UNITED STATES  
NUCLEAR REGULATORY COMMISSION  
WASHINGTON, D. C. 20555

Docket No. 50-309

Maine Yankee  
Emergency Plan  
Review Comments

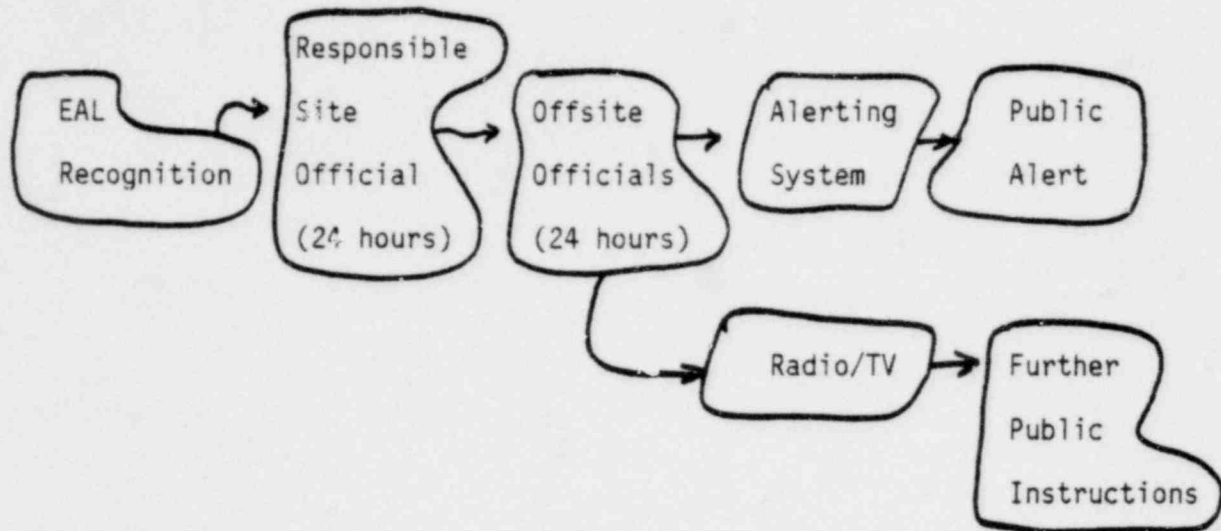
Clearly state that the offsite authorities responsible for implementation of offsite protective measures shall review and concur in the EALs.

The EALs for the conditions specified in Table 4-1 for a general emergency must include corroborating evidence from two independent sources; in addition, time factors (e.g., containment pressure greater than 20 psi for 3 minutes) should be provided.
